6671A-11

S E R V I C E N O T E

**6671A DC POWER SUPPLY, 0-8 V, 0-220 A, 1760 W.
GBIB CONTROLLED.**

Figure 1

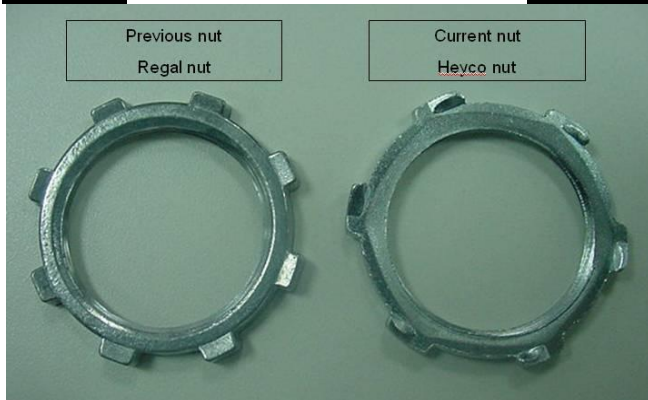
When the incorrect nut is used or a locking Nut is put on incorrectly the strain relief will become loose.

Figure 1 is an example of what happens when the strain relief becomes loose, the line cord becomes twisted. When a heavy line cord is used the strain relief becomes loose very easily, and the line cord cable can rotate freely.

Figure 2 shows the inside of the AC Safety Cover housing the incorrect hardware is shown. It will be very difficult to tighten the strain relief. AMC (Asian Manufacturing Center) uses a special tool to tighten the locking nut. When the incorrect nut is used or a locking Nut is put on incorrectly the strain relief will become loose as described above.

The entire **AC INPUT SAFETY COVER** P/N 5040-1676 should be replaced.
